Errata to the Final Revised EIR

The County has prepared this Errata sheet to clarify and correct information in the Final Revised Environmental Impact Report (Final Revised EIR) for the Flood County Park Landscape Plan. These minor changes do not introduce new or more severe adverse environmental effects and do not address feasible alternatives to the Project or mitigation measures beyond those considered in the Draft Revised EIR and Final Revised EIR. Therefore, the revisions herein do not contain significant new information pursuant to *CEQA Guidelines* Section 15088.5 that would deprive the public of a meaningful opportunity to comment on environmental impacts. As a result, this Errata is not subject to the noticing and consultation requirements set forth in California Public Resources Code Section 21092.1 and *CEQA Guidelines* Section 15088.5.

Figure 5 Proposed Parking Map

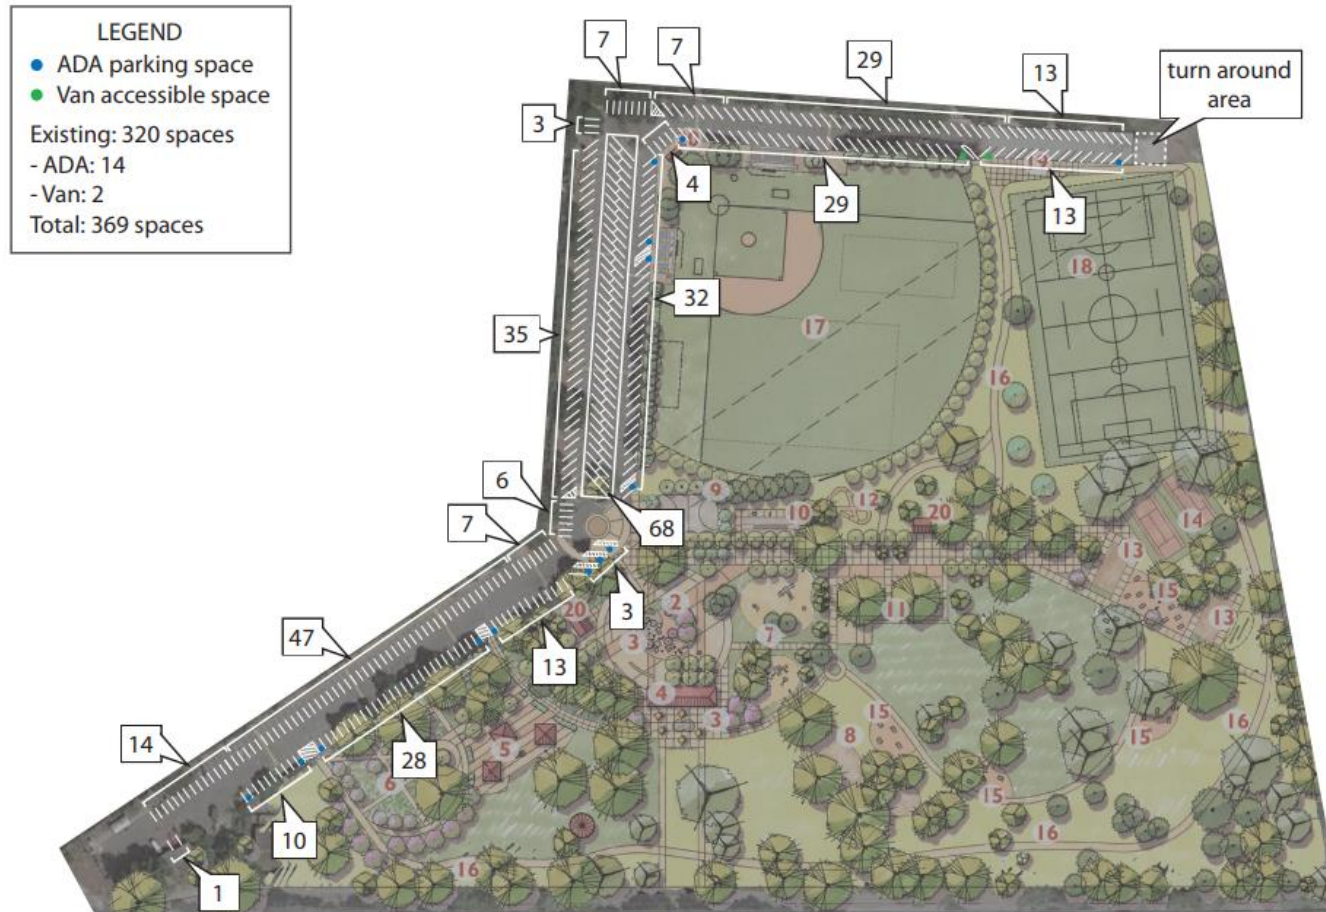
The Landscape Plan would not involve changes to parking and access, except for a new drop-off area on-site and stripping for an addition of 49 parking spaces on already paved and gravel surfaces. Flood County Park's existing vehicular access from Bay Road, via the entrance gate at the southwest corner of the park, would be retained, as would the existing asphalt parking lot on the western edge of the site. Pedestrians also would retain access to the park through entrances in a chain-link fence along Bay Road and at the eastern gate from Iris Lane. An additional 26 parking spaces and a turnaround area would be added to the site of the existing pétanque court, as shown in Figure 4 and Figure 5, Proposed Parking Map. New parking stall locations have been identified throughout the site in existing paved areas and include the following: one parking stall near the existing pay station; two parking stalls in the island near the eastward turn near the ballfield; one stall in the island behind the ranger residence; one stall in the island on the south side of the eastward turn; seven stalls in the approximately 60 foot space and four stalls in the approximately 36 foot space before the pétanque court; and seven stalls by converting ADA van parking stalls to ADA car parking stalls. Therefore, an additional 23 stalls stripped outside of the pétanque court and 26 stalls stripped within the pétanque court would add a total of 49 new parking spaces at Flood Park. Please see Figure 5 for a layout of all 369 parking spaces.
